CITY OF YPSILANTI
Agenda
Historic District Commission
Tuesday, June 26, 2018 - 7:00 p.m.
City Hall, Council Chambers, 1 S. Huron
Ypsilanti, MI 48197

HDC Work Permit Staff Review

Property address: 113 Buffalo

Proposed work: side and rear porch installation

PROJECT:
BEAL RESIDENCE
113 BUFFALO ST
YPSILANTI, MI

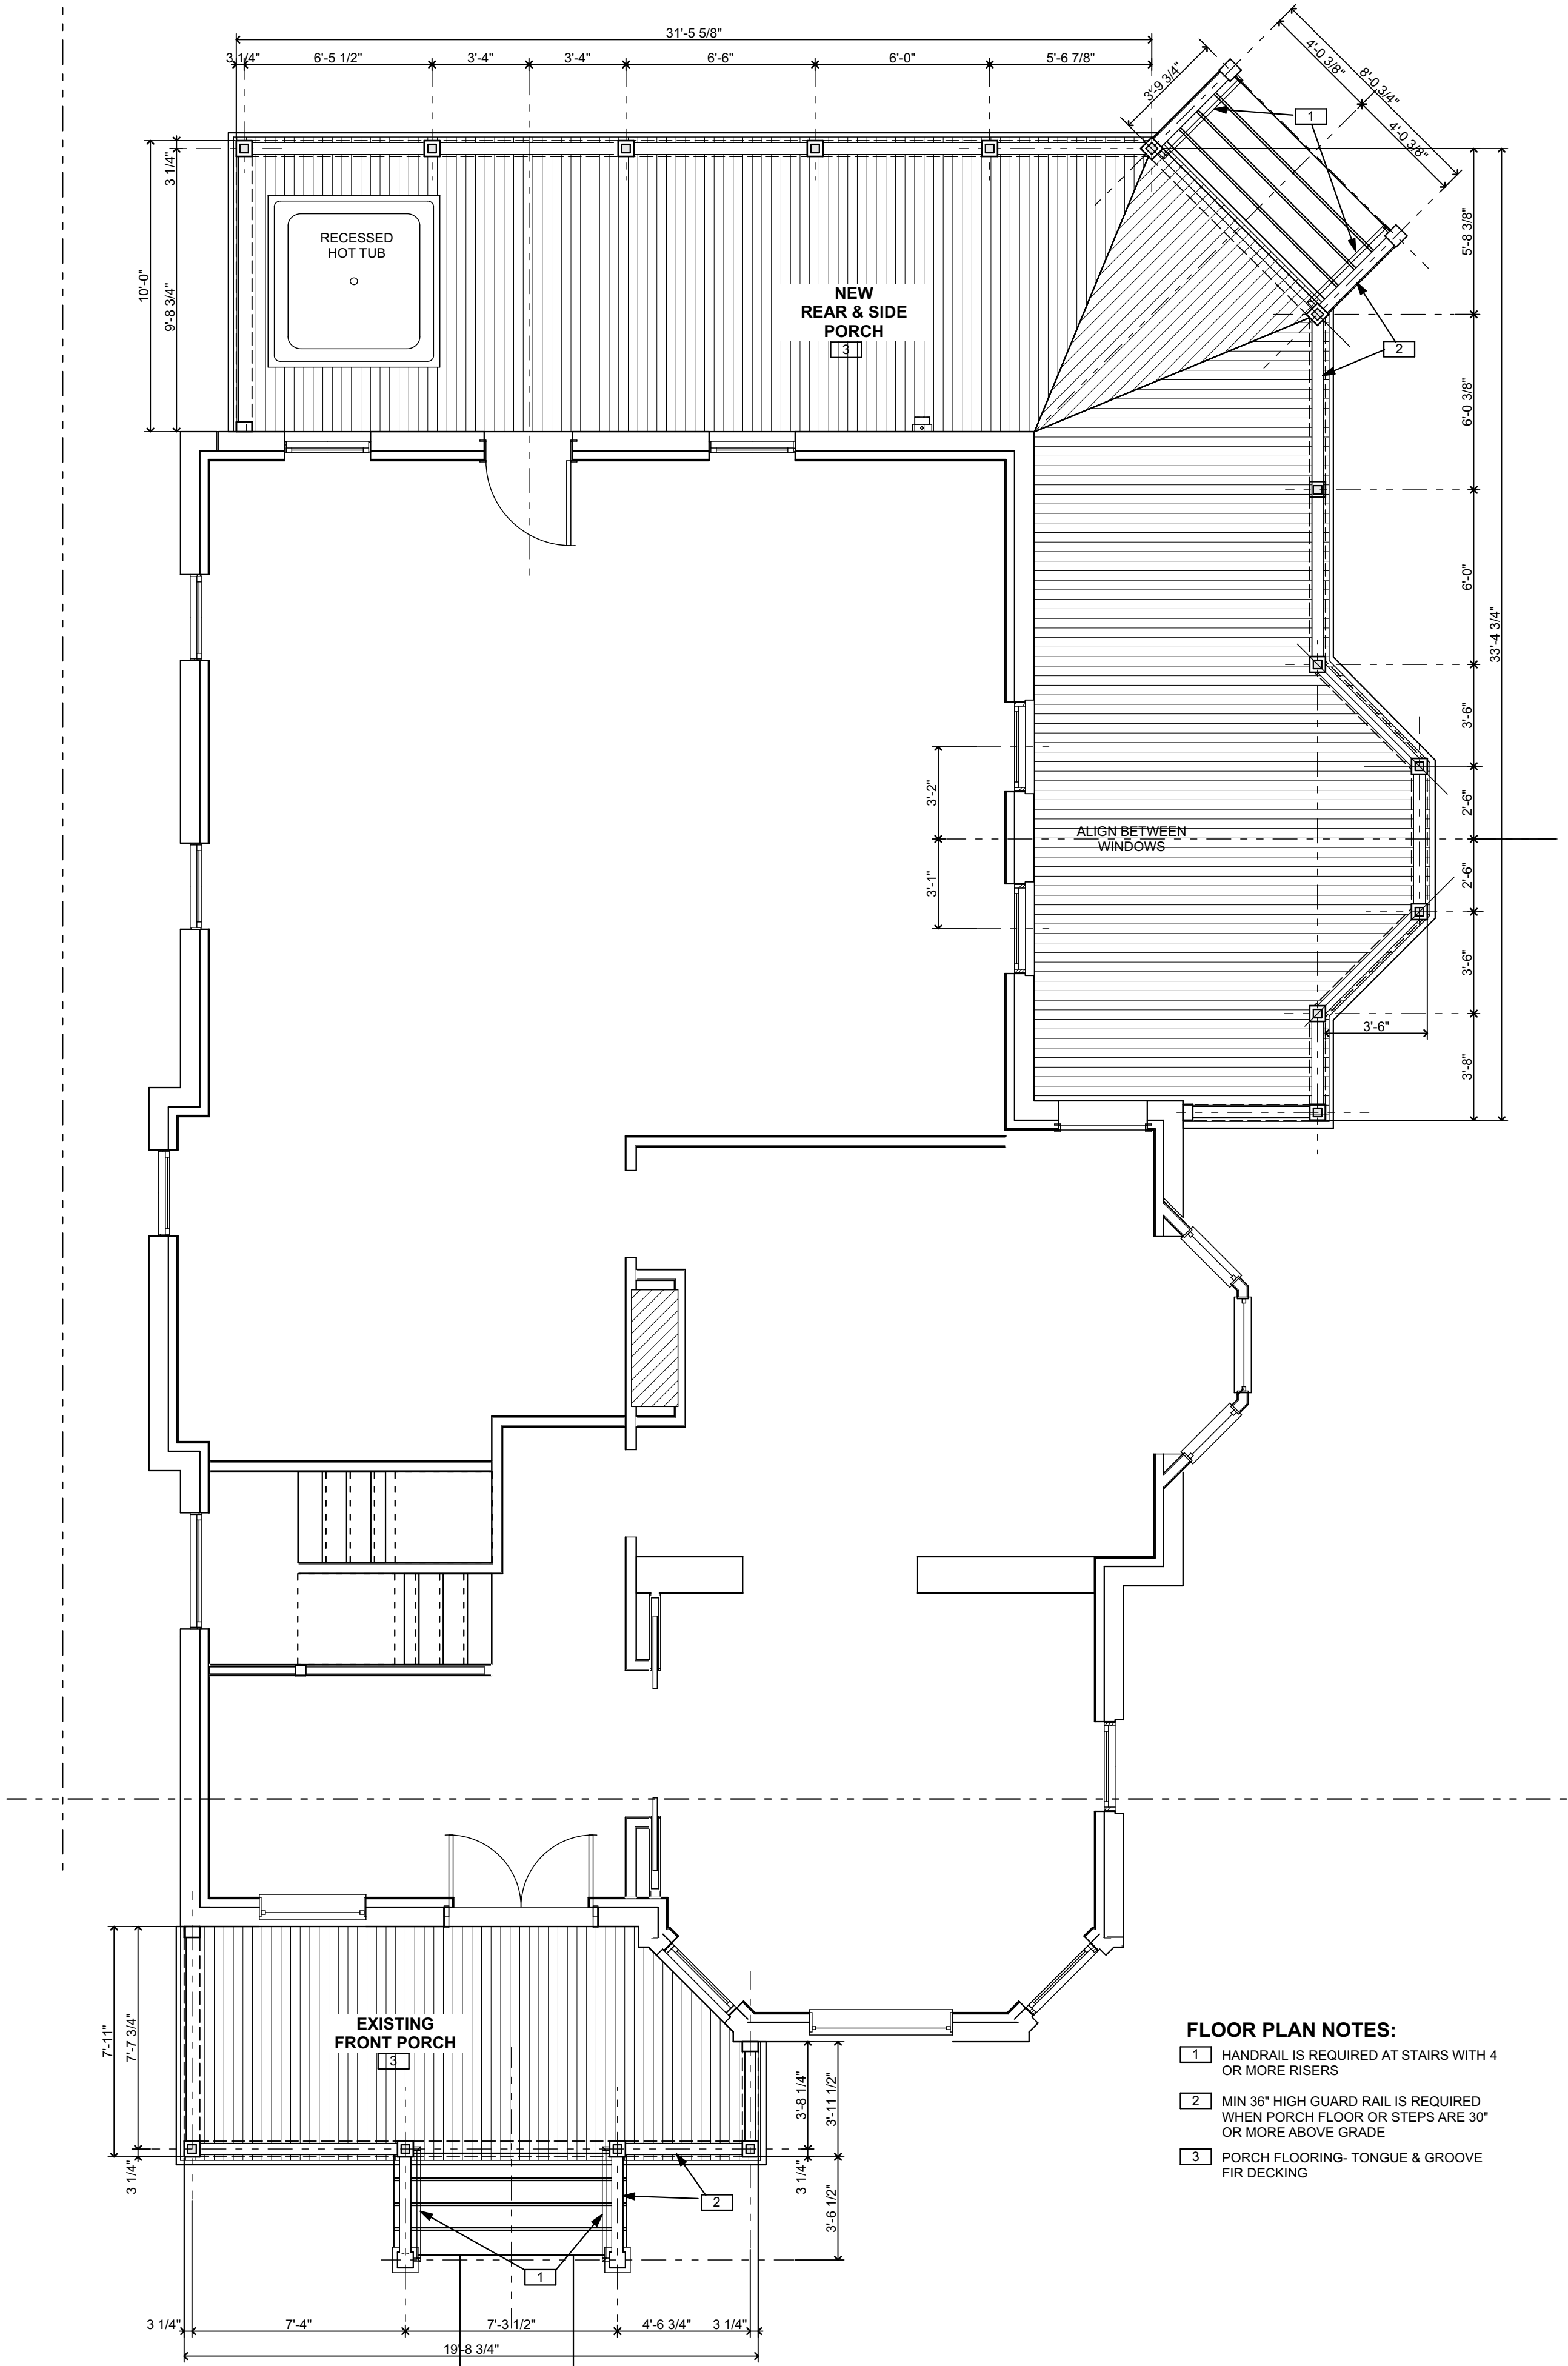
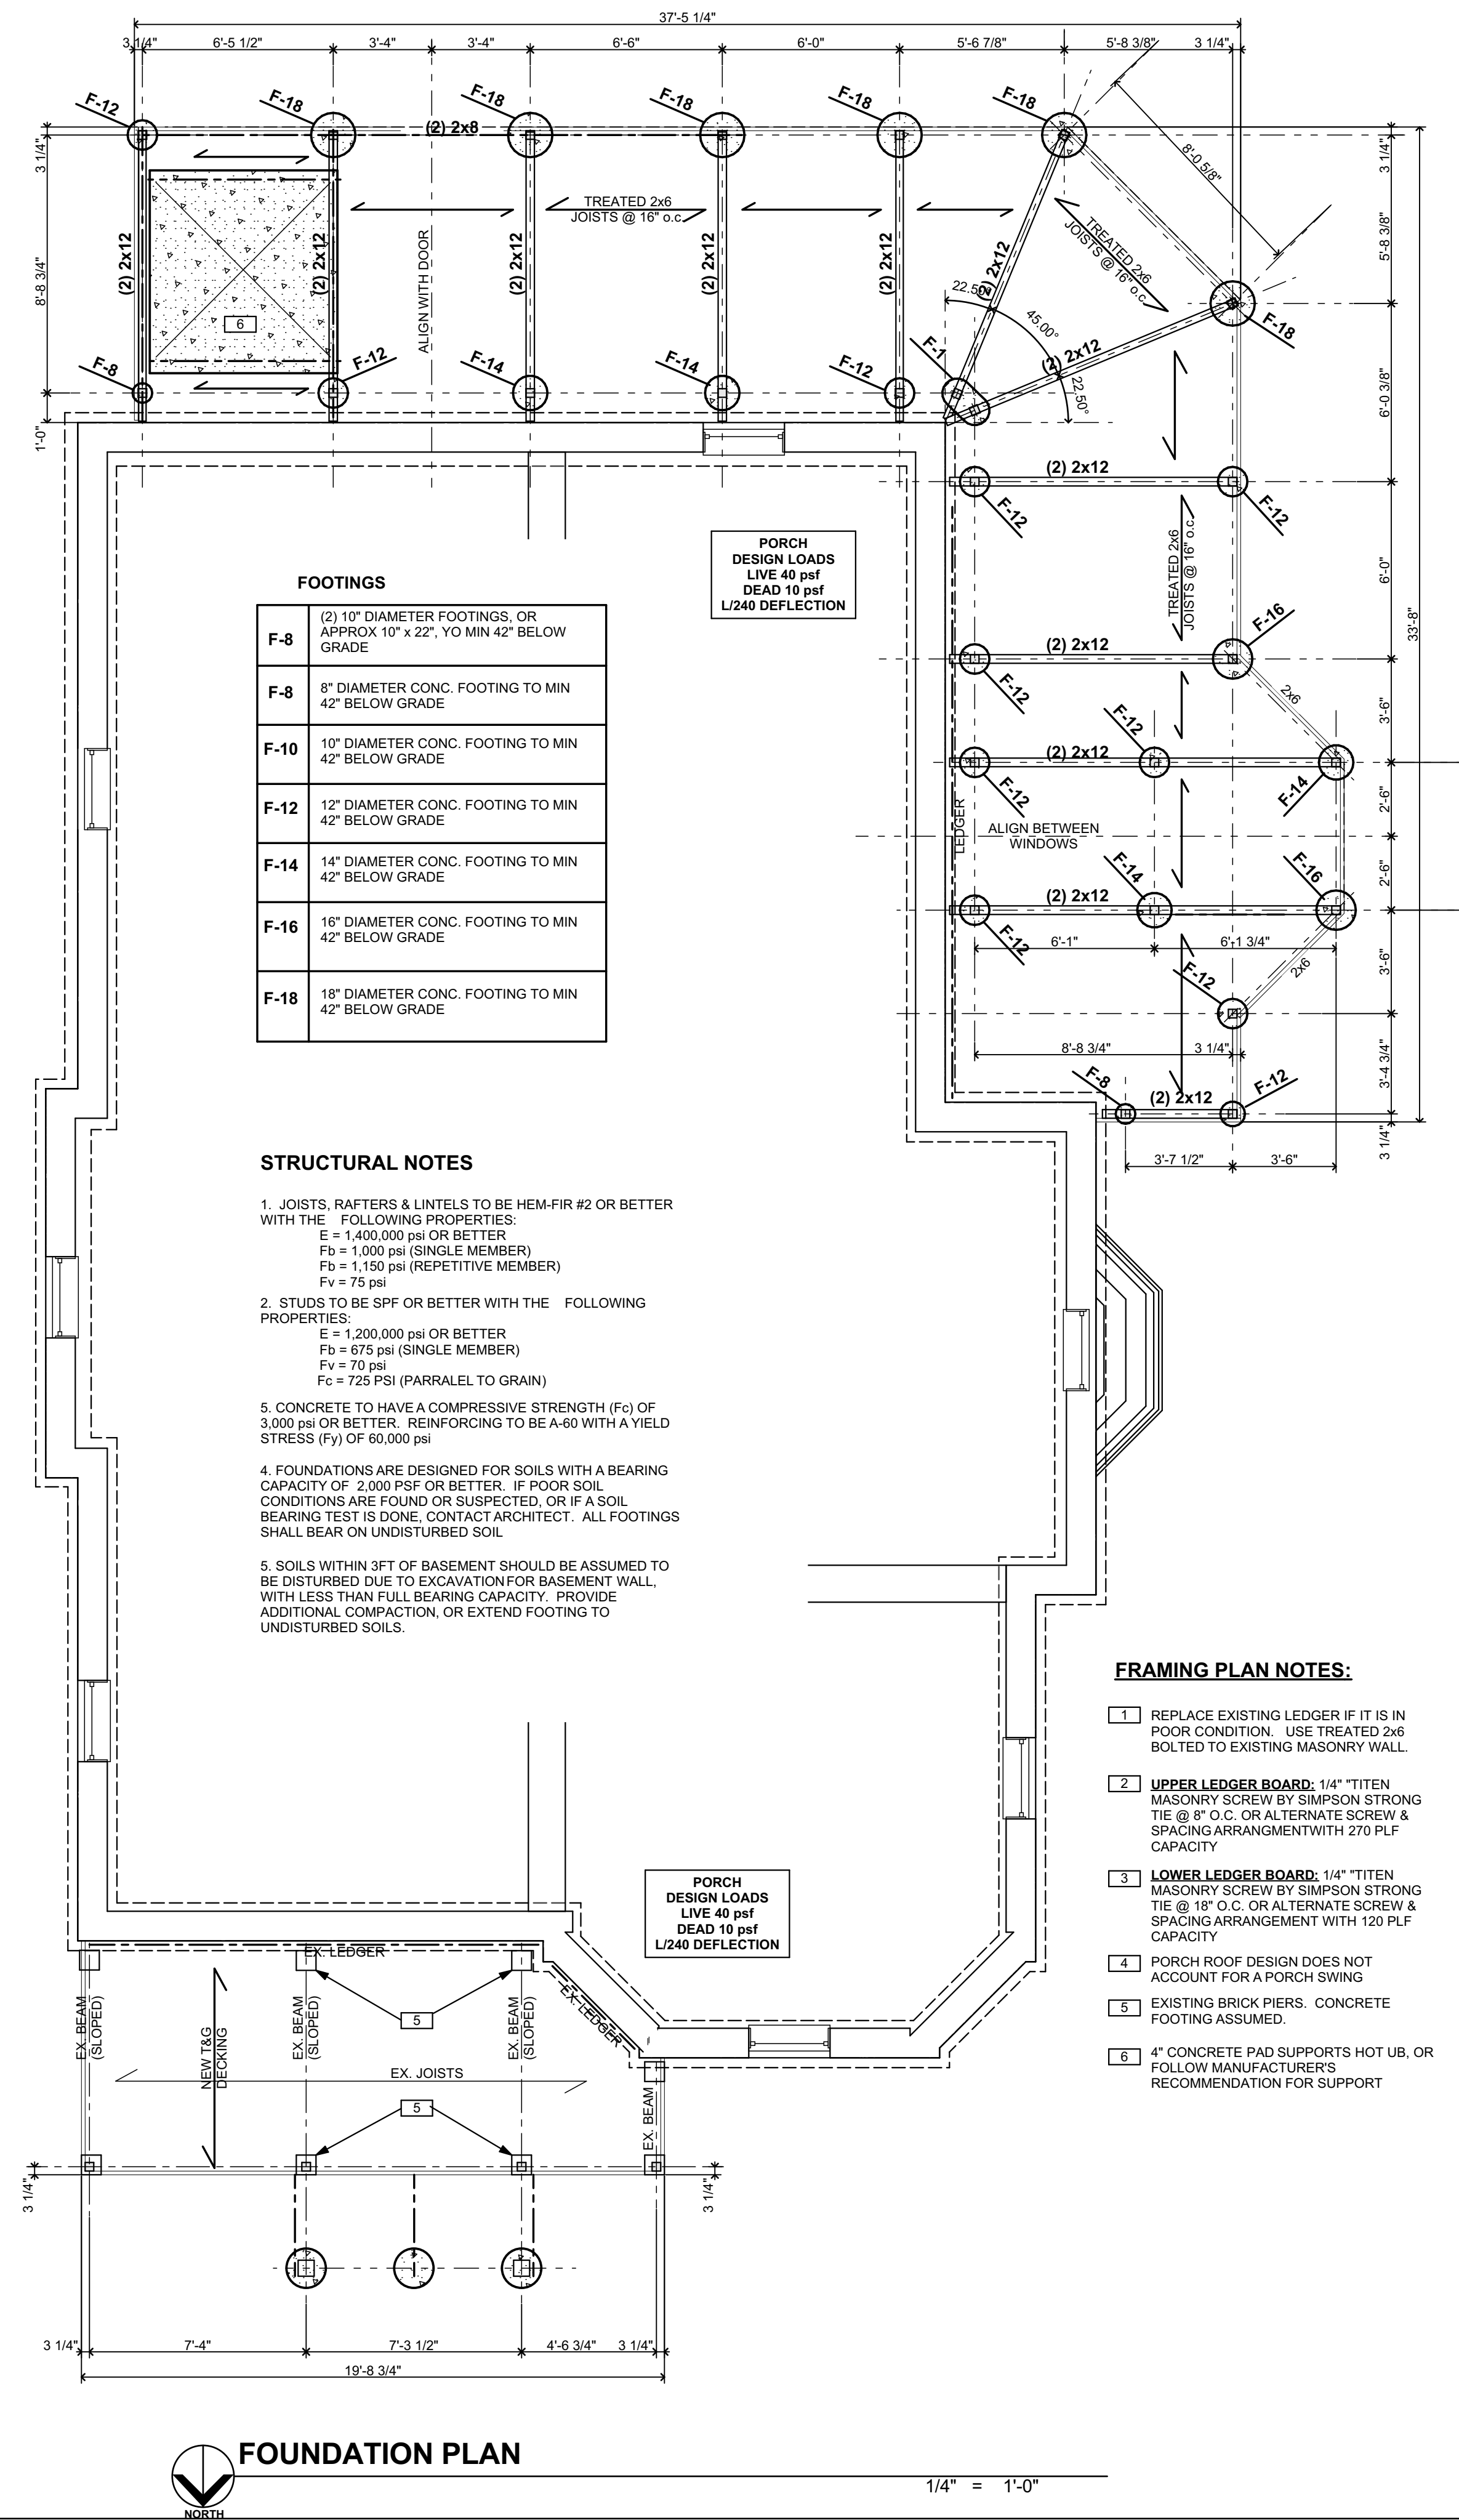
1. The applicant was tabled at the past 2 HDC meetings for a more simplified plan for the porch. The applicant has provided new plans and renderings dated June 21, 2018.

2. The applicant is looking to install a side/rear wraparound porch on the southwest side of the house, a recessed hot tub will be installed as well.
3. Changes from the originally submitted design include changes to the lattice in the skirting area, the removal of the spindles in the header area, and less details on the posts.

4. The applicant was previously approved by the HDC for the front porch rehab on September 27, 2016.
5. The applicant has included three historic photos for documentation; however this is a new porch and the historic side porch does not appear to have been a wraparound porch thus it should be differentiated from the historic style.

6. The applicant plans to use beadboard for the porch ceiling, Tamko 3-tab shingles for roofing to match the house, tongue & grove fir decking, lattice to match the plans, concrete footings, wood joists, rafters and lintels.

7. HDC to verify that the main material for the porch is wood and that all wood parts are to be fir or similar.

8. What appears to be k-style gutters are indicated on the plans. HDC to verify this and what color the gutters will be.
9. HDC to confirm the location and if there will be any additional structure above ground for the hot tub.
10. Painting on the porch will be in the following to match the house: Valspar Sequoia Glade (main), La Fonda Mirage (accent), Cincinnati Hotel Nichols Taupe (second trim)
11. A Zoning review will be required.
12. A building department permit will be required for this work and should be obtained prior to the start of any work.

Move to approve the application for work on 113 Buffalo St to include the installation of a wood side and rear wraparound porch as depicted in the architect plans and renderings dated June 21, 2018. Work to include the installation of fir porch decking, a bead board porch ceiling, and concrete footings with Tamko 3-tab shingles on the roof to match the main house. The porch is to be painted in the existing color scheme of the house: the main color is Valspar Sequoia Glade, the accent color is La Fonda Mirage and the second trim color is to be Cincinnati Hotel Nichols Taupe. K- Style gutters will be installed and painted to match the color scheme. A hot tub will be recessed into the ground at the southeast corner of the rear portion of the porch.
